APPLICANT'S RESPONSES TO RELEVANT REPRESENTATIONS AND ADDITIONAL SUBMISSIONS

Drax Bioenergy with Carbon Capture and Storage

Document Reference Number: 8.3

PINS Reference: EN010120

Ground Level Over Cross Section

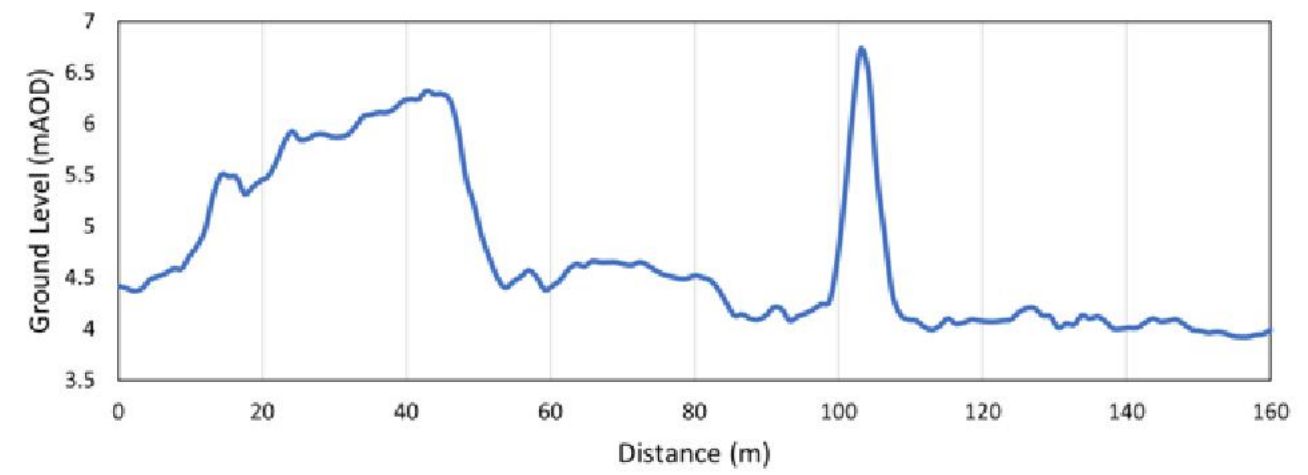
4.5	<p>Table 12.6 Surface Water Features within the study area that have the Potential to be Affected by the Proposed Scheme. Several of the ponds within this table which have a recorded presence of Great Crested Newt are not considered as 'sensitive receptor'. We disagree with this as they may be a habitat of the Great Crested Newt, which is a protected species and therefore a 'sensitive receptor'.</p> <p>This issue has also been raised in the Additional Submission Document Ref AS-040.</p>	<p>Whilst these ponds could be considered as a sensitive receptor as the presence of Great Crested Newt has been recorded / provide suitable habitat, they are not likely to be affected by the construction of the Proposed Scheme given that they are separated from the Proposed Scheme and Construction Areas, by an earth embankment, as shown in the image below, which would prevent any pollutants / contaminants which are accidentally released from the construction of the Proposed Scheme from reaching them.</p>
